SJOET Well Work Procedure

Hardie LS #9

Attachment to Notice of Re: Permanent Abandonment

Intention to Abandon Well: 9 Hardie LS

HARDIE LS 009
Location — 26A— 29N— 8W
SINGLE PC
Orlg.Completion — 5/73
Last File Update — 1/89 by DDM

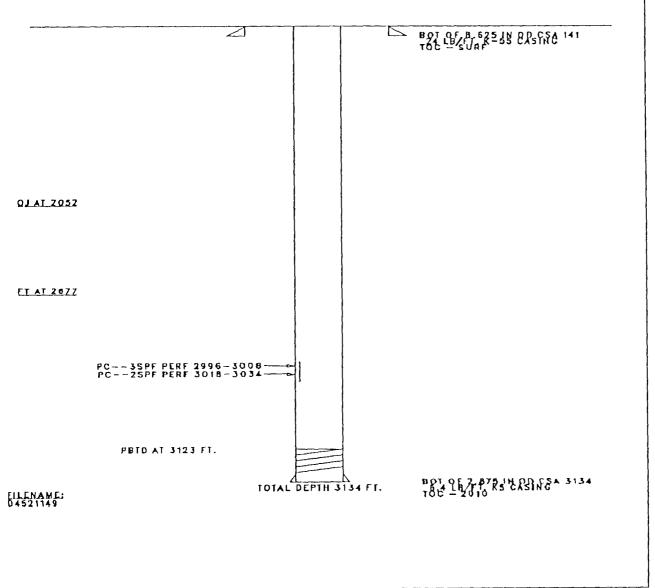
If circulation to the surface can not be established from the perforation at the top of cement determined from the CBL, at a minimum, place cement plugs at the following intervals:

- 1. Place a cement plug from 2201' to 1923' inside and outside the casing. (Ojo Alamo 1973' to 2151')
- 2. Place a cement plug from 724' to 624' inside and outside the casing. (Nacimiento top at 674')
- 3. Place a cement plug from 191' to the surface inside and outside the casing. (surface casing at 141')
